STAFF RECOMMENDATION

NCPC File No. Z.C. 06-14

CONSOLIDATED PLANNED UNIT DEVELOPMENT FOR WASHINGTON GATEWAY AT NEW YORK AND FLORIDA AVENUES, LOTS 23 AND 811-813 IN SQUARE 3584 NORTHEAST WASHINGTON, DC

December 28, 2006

Office Building West Facade @ Plaza

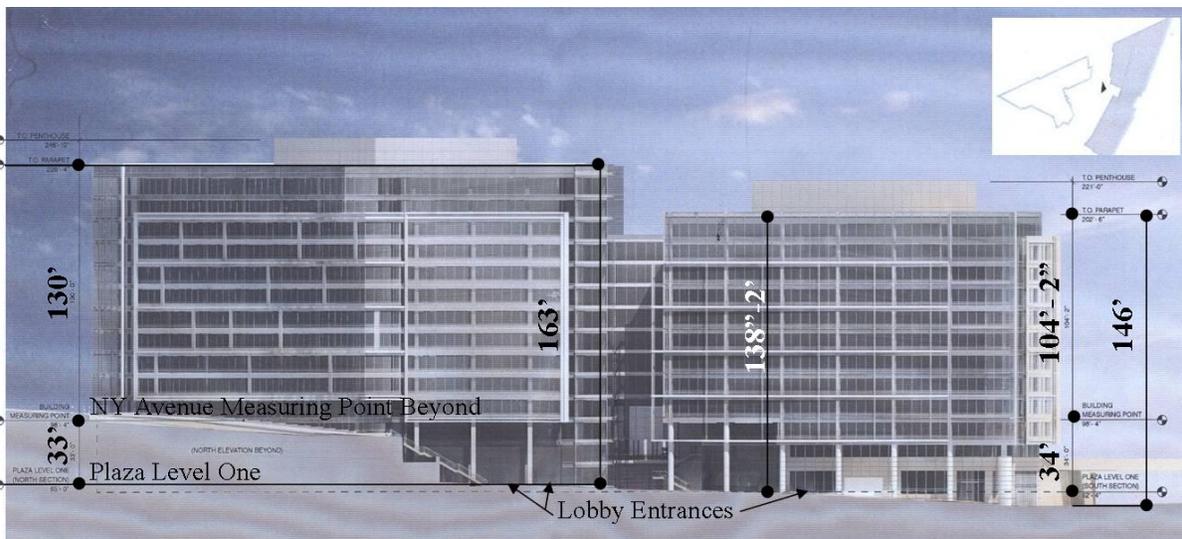
The north wing height would rise 130 feet above its measuring point on the elevated embankment approaching the New York Avenue viaduct. Once the site drops slopes down sharply and flattens out, the north wing would measure 163 feet above the grade at plaza level 1, where its lobby would be accessed. Access to loading and parking would occur as the plaza slopes further towards Florida Avenue. The south wing would measure 138 feet above grade at the plaza and 146 feet above grade at Florida Avenue. One level above at level 2, the MBT atrium would connect to the bike path. At the next level up, level 3, stairs from the plaza would approach the elevated sidewalk at New York Avenue, with no storefronts or entrances from the avenue. Along the New York Avenue street wall, linear elements would overlay the glazed curtain wall façade to create a vertical and horizontal pattern above the pedestrian level. The same patterned facade elements would occur on all other facades, but “rhythms at the scale of a single story”, which “occur near pedestrian activity”, occur only interior to the site.

Charrette Concept B Diagram for Transforming the Intersection

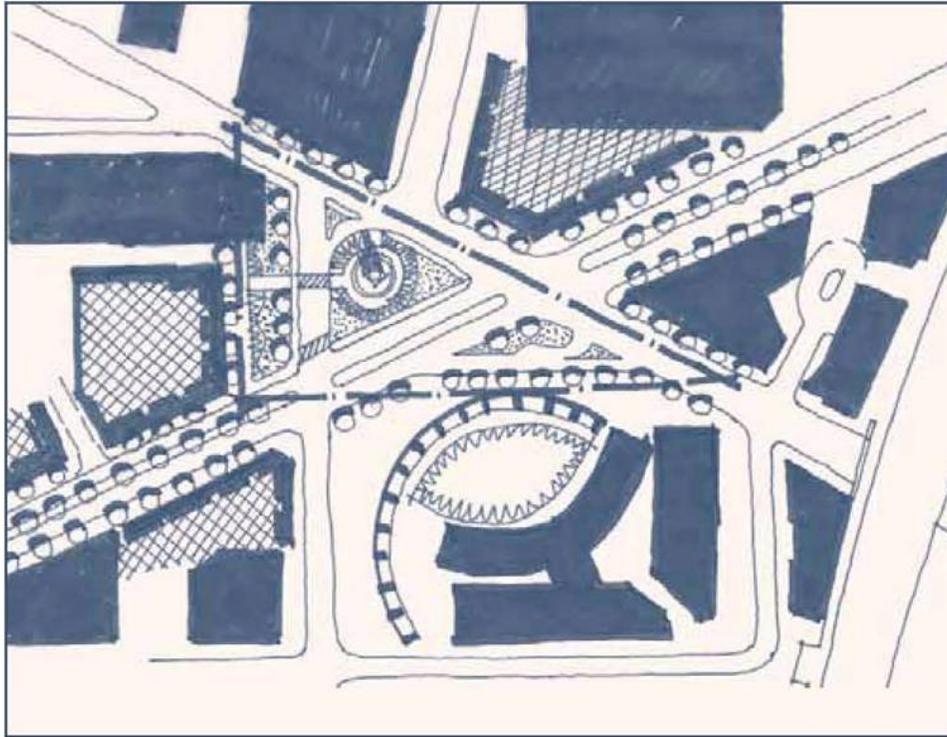
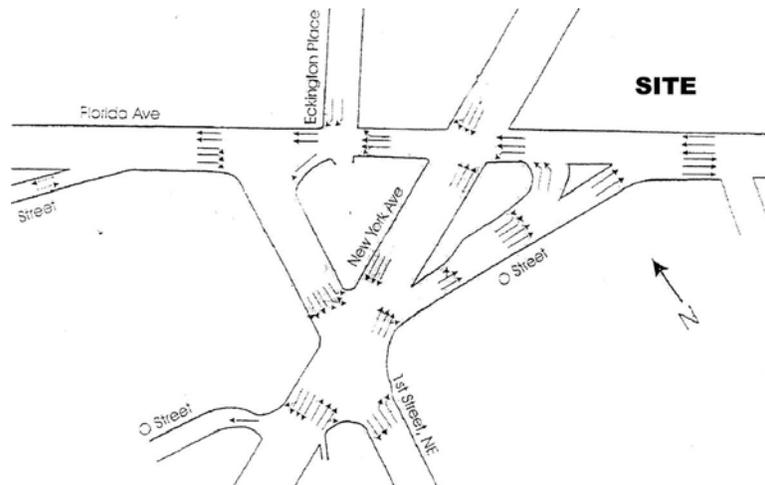
memorial opportunity at the intersection, the other two diagrams (Concept B shown as example) illustrate the current PUD proposal configuration. Staff believes that locating a parking garage entrance and a loading dock entrance in the locations shown in the current proposal is inconsistent with the goal of having a significant commemorative works site at the intersection.

DDOT's Near Term Plan: Virtual Traffic Circle for the Intersection

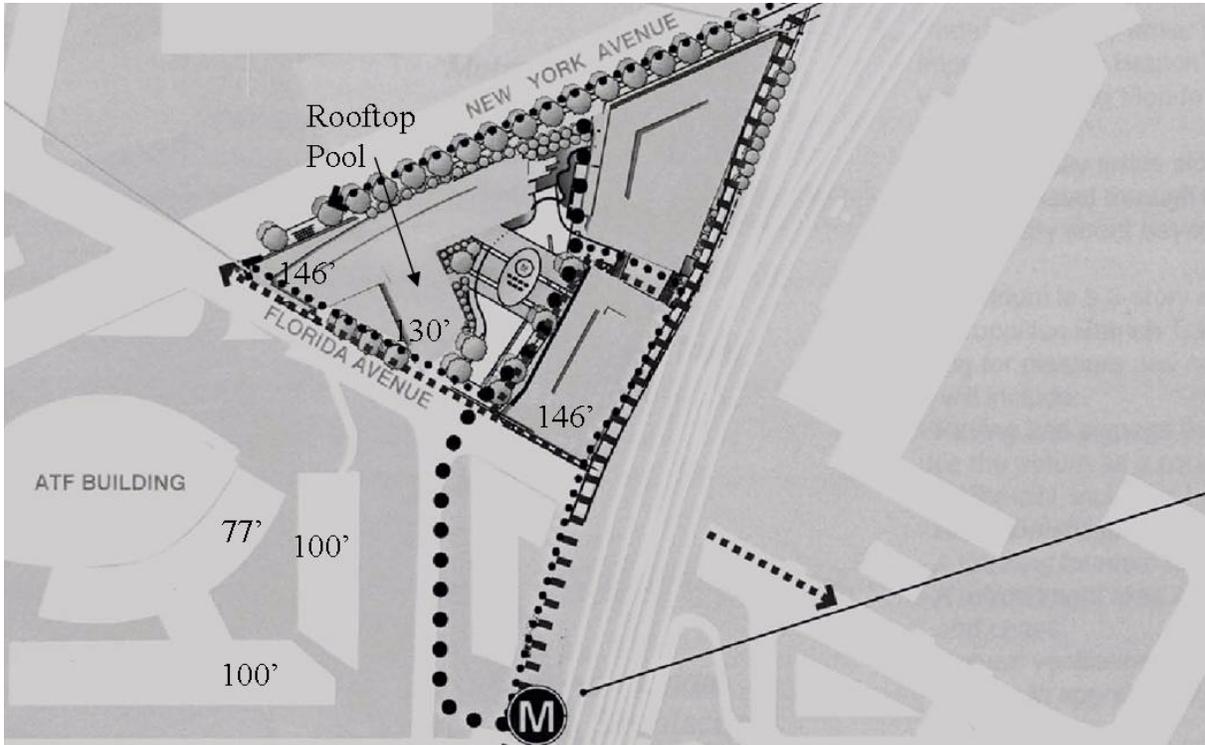
The DCOP staff report further notes that the proposed design is now consistent with the DDOT recommendations for intersection changes as shown in the final Draft New York Avenue Corridor Study. While the PUD design, and even the two curb cuts near the intersection, have been coordinated with DDOT's near term plan to reconfigure the intersection to function as a

virtual circle, the Corridor Study also includes comprehensive urban design recommendations for knitting the city together. The Study calls for special identity focal points to create active pedestrian spaces and help to tie Florida, North Capitol and New York Avenues together, with open space reserved for creation of pedestrian activity at intersection corners. Although as submitted the PUD design for the residential/hotel building notches back slightly at the corner to reveal a covered area, no activity will be programmed. More importantly, the two vehicle entrances in such close proximity to the intersection would diminish opportunities for locating a significant commemorative work in this area.

Proximity and Impact on ATFE HQ Building

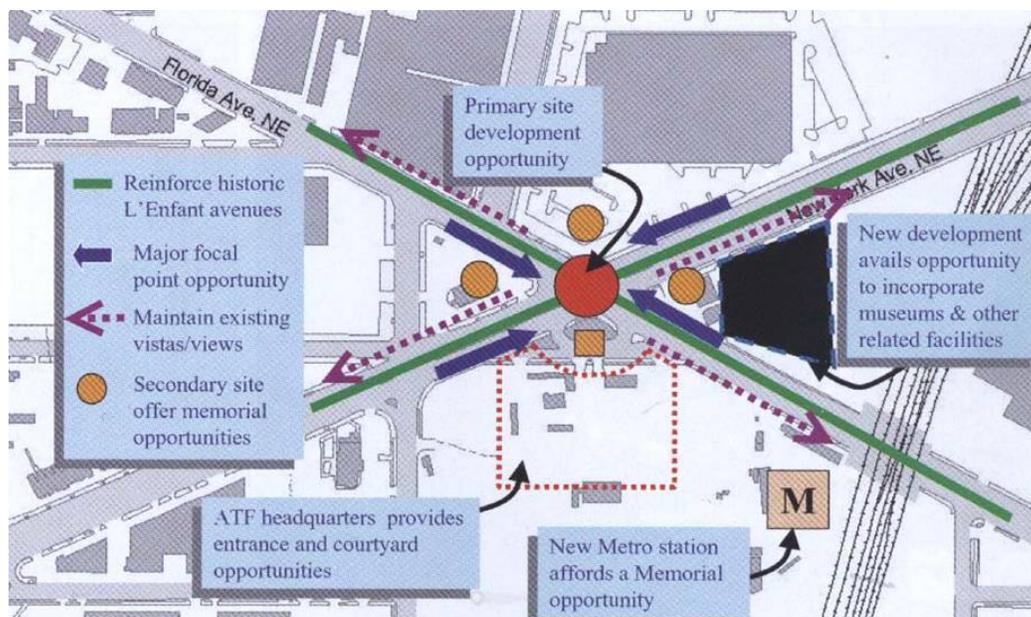
At approximately 146 feet high along Florida Avenue, the height of the residential/hotel building is inappropriate and could create security issues for the Bureau of Alcohol, Tobacco, Firearms and Explosives Headquarters Building (ATF&E HQ). Because the measuring point used is on New York Avenue where it rises to cross the Metrorail tracks, the building height as measured along Florida Avenue across from the Bureau of ATF&E HQ Building is over 130'. The two highest building wings both reach 146 feet above grade at Florida Avenue. The residential wing closest to the Bureau of ATF&E HQ Building is 130 feet above grade with a pool on the roof of the wing closest to 2nd Street. The General Services Administration (GSA) has notified staff that they have security concerns that should be evaluated regarding the height of the project relative to the ATF&E HQ Building through consultation and referral between the applicant and GSA.
